Technical Service Bulletin

Subject: AIR BAG WARNING WITH DTC B1126:13 OR B1127:13	Bulletin No.: 08-002/22
	Last Issued : 09/13/2022

APPLICABLE MODEL(S)/VINS

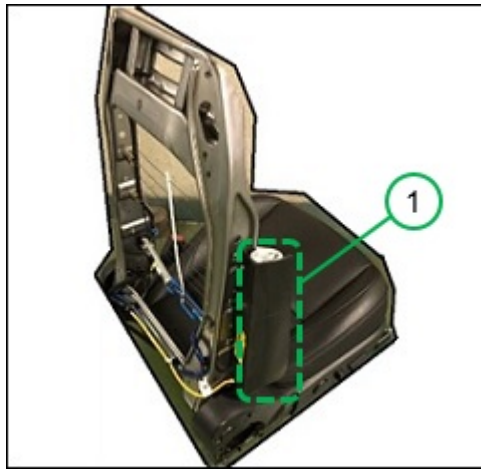
Some vehicles may exhibit that the air bag warning light turns on or repeats cycles of turning on and off with DTC B1126:13 and/or B1127:13 stored in memory.

- When the driver or passenger moves, a load is applied to the seat back and the load may cause displacement of the mating terminals in the side air bag module connector, resulting in insufficient contact and higher resistance.
- The DTC detection level is too sensitive.

- The design of the connector terminals in the side air bag module has been modified for firmer contact.
- The DTC detection level of the SAS control module has been optimized.

1. Verify the customer concern.
2. **[For 2020-2022 CX30 with VINs lower than 3MVDM*****414338 (produced before Feb. 27, 2022)]** Replace the affected side of the side air bag module(s) (1) with modified one(s) according to instructions on MGSS.
 - US/Canada spec: (SIDE AIR BAG MODULE REMOVAL/INSTALLATION [TWO-STEP DEPLOYMENT CONTROL SYSTEM - US/CANADA SPEC.]).
